# 1984 Corvette: Service Bulletin: Rear Hatch Defogger Circuit Revision

**Subject:** Rear Hatch Defogger Circuit Revision

**Model and Year:** 1984 Corvette

**Bulletin No:** 84-252

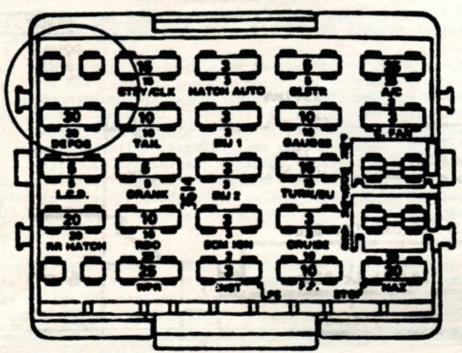
- 1. Disconnect the negative battery cable.
- 2. Remove both left and right hush panels.
- 3. Fabricate the mirror glass heater jumper harness.

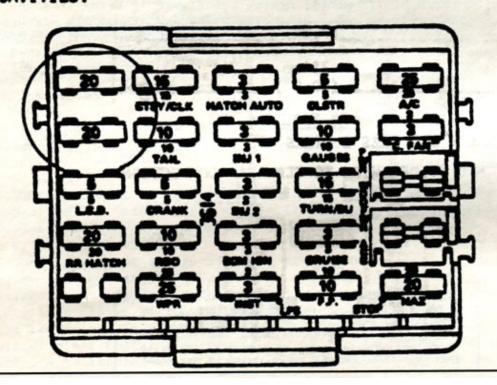
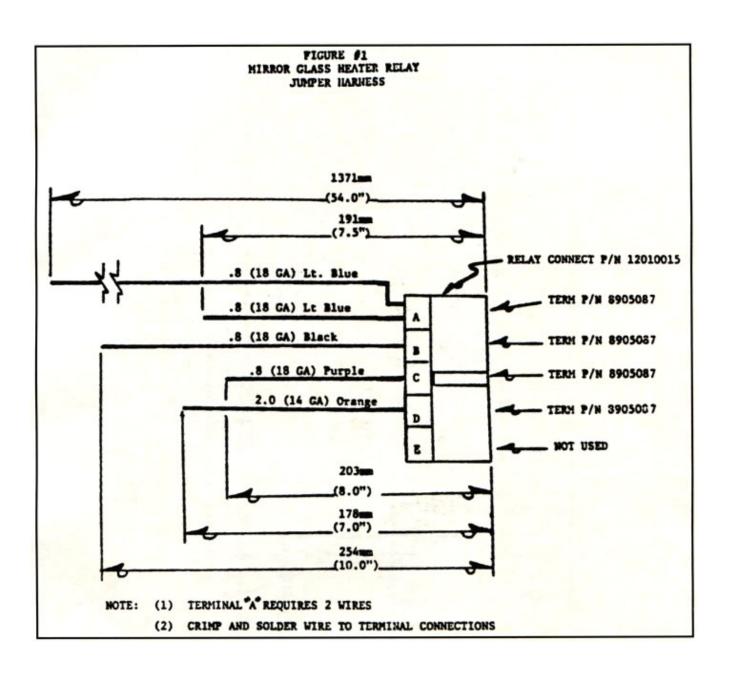
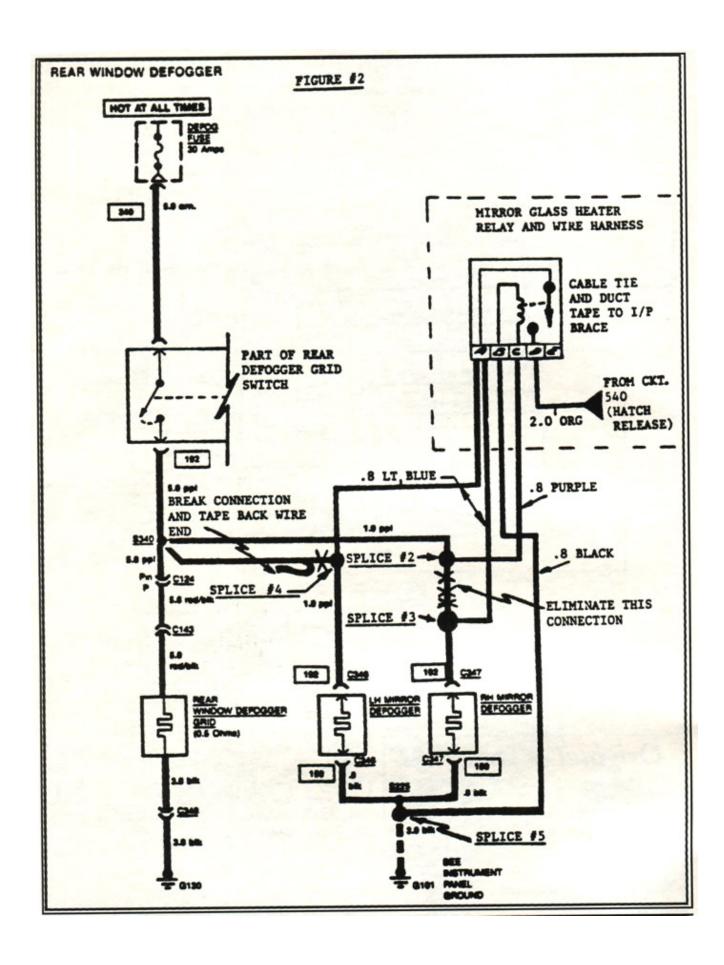
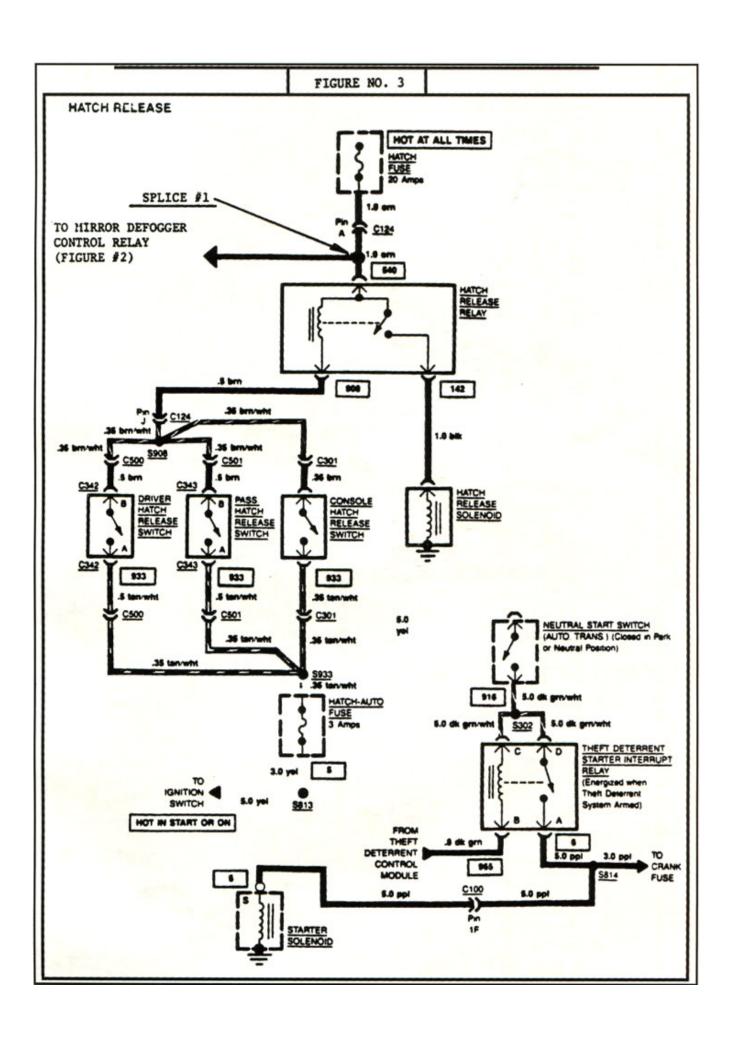
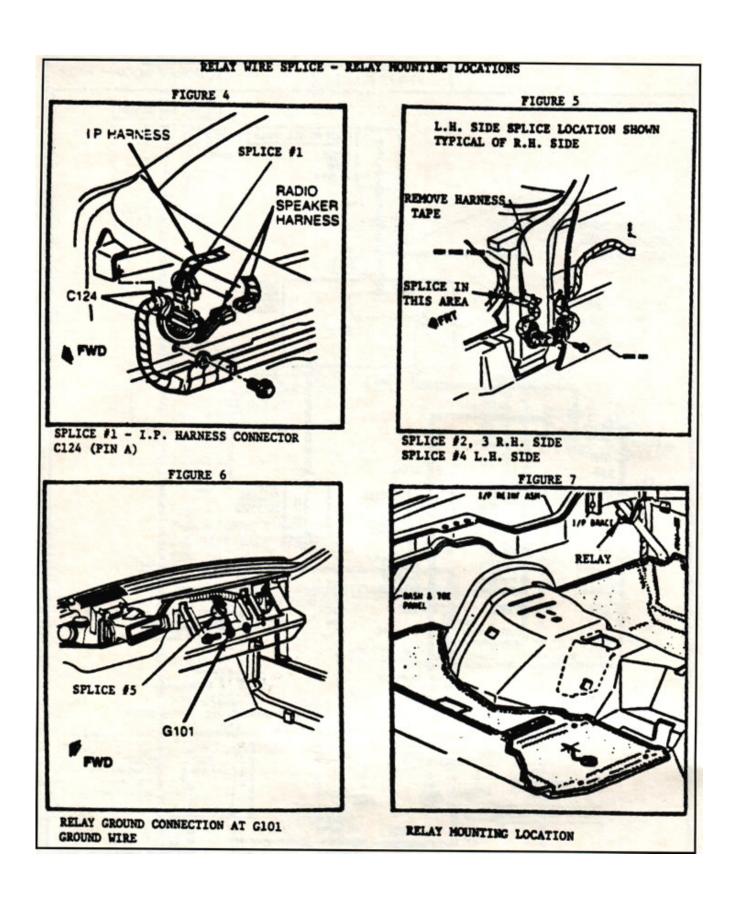
On vehicles built prior to serial number E5144571, the 30 amp load is the maximum allowable current on the defogger circuit. It has been decided to remove the side door mirror glass heater high current load from the defogger

circuit and move it to the rear hatch release feed circuit (See Figures #2 and #3.)

- 4. Solder Splice #1 locate circuit 540 (Figures #3 and #4) at the I/P harness connector C124, Pin A. Remove approximately 15mm (.62 in.) of insulation from the (16 ga.) orange circuit 540 supply wire. Strip and wrap and mirror replay harness (14 ga.) orange wire (relay terminal E) around the stripped (16 ga.) orange circuit 540 wire and solder to complete the splice. Tape splice to insure proper electrical insulation.

- 5. Solder Splice #2 and #3 locate circuit 192 (Figures #2 and #5) under the R.H. side of the dash. It will be necessary to remove the production harness tape to locate the 16 ga.) purple wire to the R.H. mirror glass heater. Cut and strip both ends of this wire. Solder splice the (18 ga.) purple wire from Pin C of the mirror relay harness into the 192 circuit wire end coming from the I/P harness (See Figure #2, Splice #2.) Solder splice the 191mm (7.5 in.) long (18 ga.) light blue

- relay harness wire (Relay Pin A) to the remaining circuit 192 stripped wire end leading to the R.H. mirror glass heater (See Figure #2, Splice #3.) Separate and tape splices to insure proper electrical insulation. Gather and re-tape R.H. door harness wires.

- 7. Locate circuit 192 under the L.H. side of the IP (See Figures #2 and #5.) Removal of the production harness tape will be required to expose the (16 ga.) purple circuit 192 wire. Cut and tape back the (16 ga.) purple circuit 192 wire leading from the I/P harness.

- 9. Splice #5 locate the (12 ga.) black circuit 150 ground wire under the R.H. side of the dash (See Figures #2 and #6.) Remove approximately 15mm (.62 in.) of insulation from this wire. Strip and wrap the (18 ga.) black (Relay Pin B) mirror relay harness wire around the circuit 150 ground wire and solder. Tape splice to insulate.

OWNER MANUALS AND VEHICLES BUILT PRIOR TO SERIAL NUMBER 44571 ARE AS SHOWN ABOVE. SUBSEQUENT VEHICLES ARE EQUIPPED WITH TWO 20 AMP FUSES, BUT THE FUSE PANELS HAVE NEITHER IDENTIFYING FUSE RATINGS NOR CIRCUIT NAMES PRINTED ON THE BODY UNDER THE FUSE CAVITIES.

This condition has been corrected, starting with vehicle number E5144571, by replacing the (1) 30 amp fuse labeled "defog" in the fuse block with (2) 20 amp fuses in parallel. These fuses are located in the two (2) top left hand cavities of the fuse block (see the two (2) views of the fuse block.)
